IMPERIAL METALS CORPORATION

GEOTECHNICAL REVIEW, DRAINAGE ASPECTS

MAIN EMBANKMENT DAM

TAILINGS STORAGE FACILITY

Photo 17. Previous Stream and Trail of Juncture with West Edge of Basin Liner. Looking North-West.

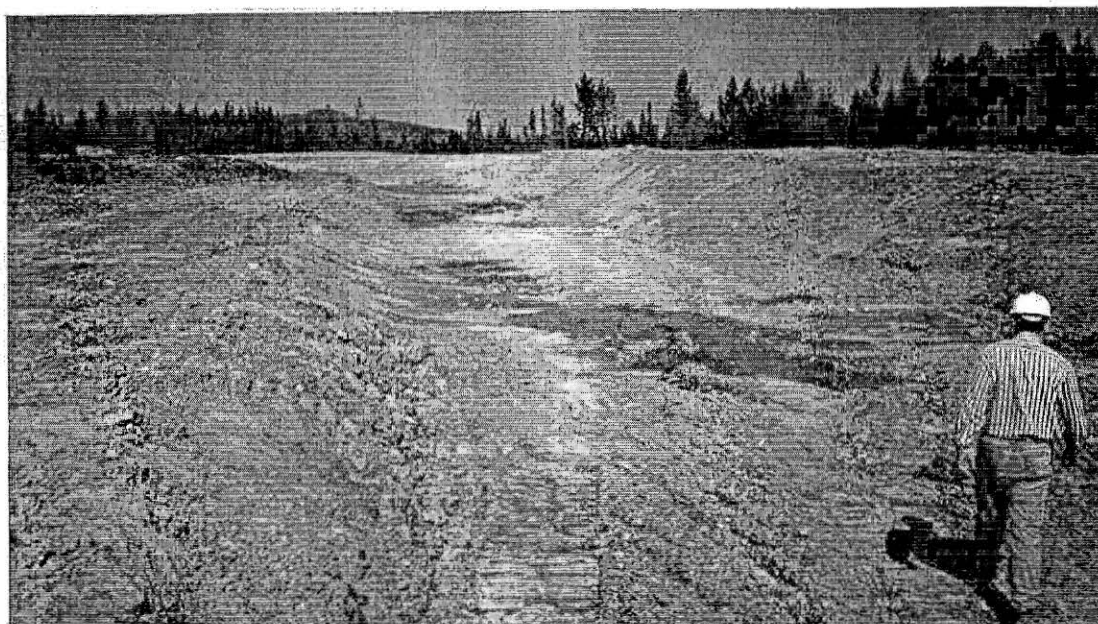
The till cap appears to have been completely removed locally in the base of the Reclaim Barge Channel (Ref. 9.8 and Photo 19, Appendix I). It was also recommended that these local areas be checked and sealed, as required. Similarly the local area, (probably a former stream bed) at the upstream edge of the Basin Liner. (Photo 17 in Appendix I).

Photo 23. Flow from a Cased Borehole Near Junction of West Perimeter Road and Proposed South Embankment.

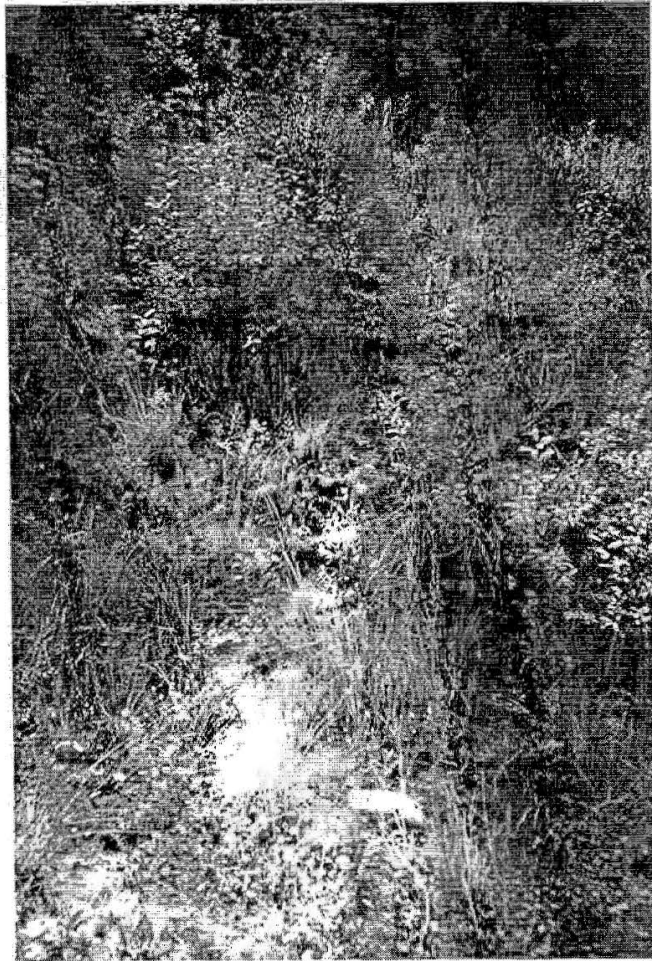
(ix) Photo 23 shows artesian flow from a well adjacent to the perimeter road along the West side of the Tailings Area, (probably Monitoring Well MP89-236). (Ref. 9.4).
